## **Trails, Beaches, Watercraft Access – Map, maintain, replace**

**Subject:** **Map, maintain, replace social trails and beaches, small watercraft put-in and take-out points, use only round cobble and gravel for these access points.**

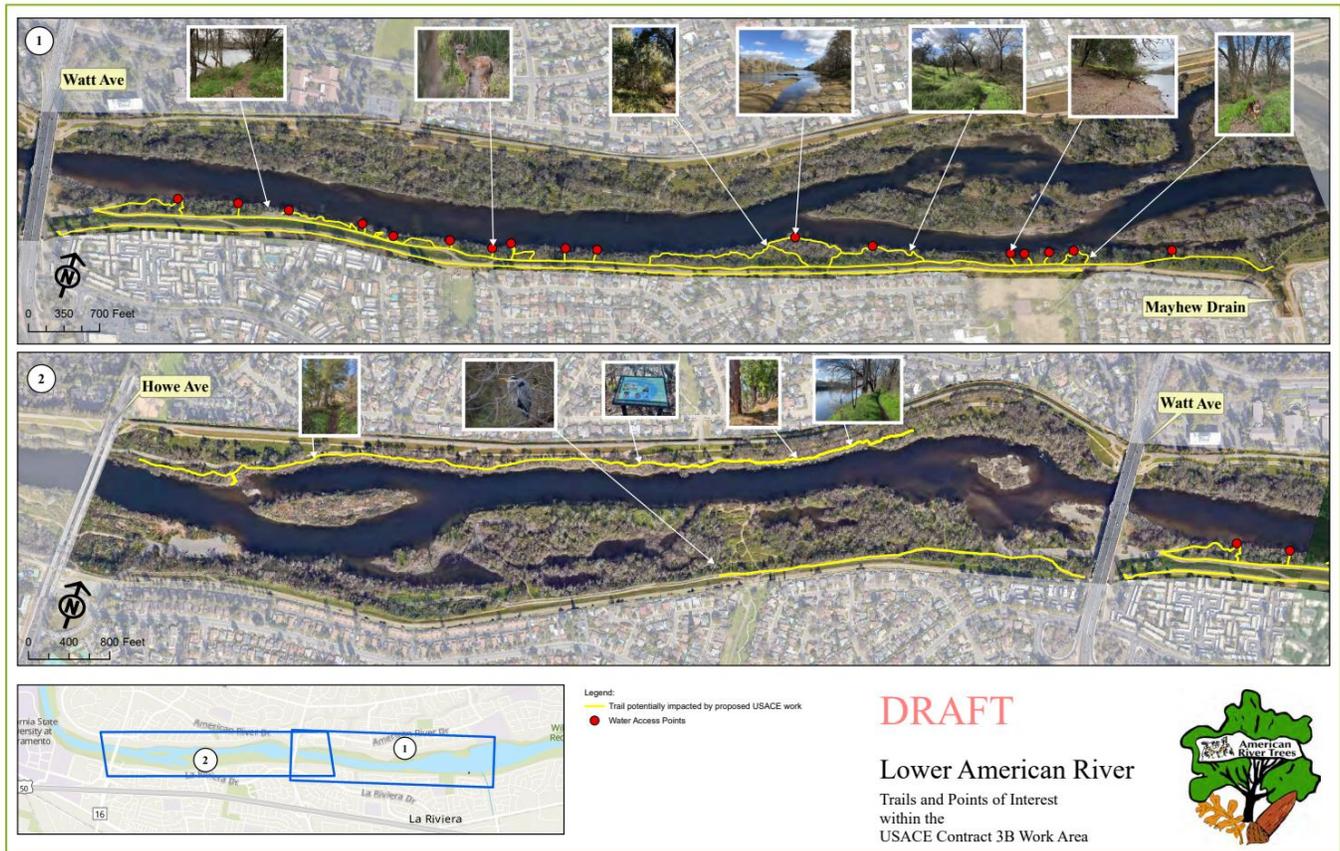
By carefully surveying with GPS, American River Trees has created a Draft working map of the known social trails and river access points that will be impacted by the bank clearing and riprapping proposed by C3B. This map is geo referenced with GPS and can be used with tracking programs such as AvenzaMaps.

We ask that USACE coordinate with Sacramento County Regional Parks to protect, and retain the general character, of all the trails and river access points depicted in the map below:
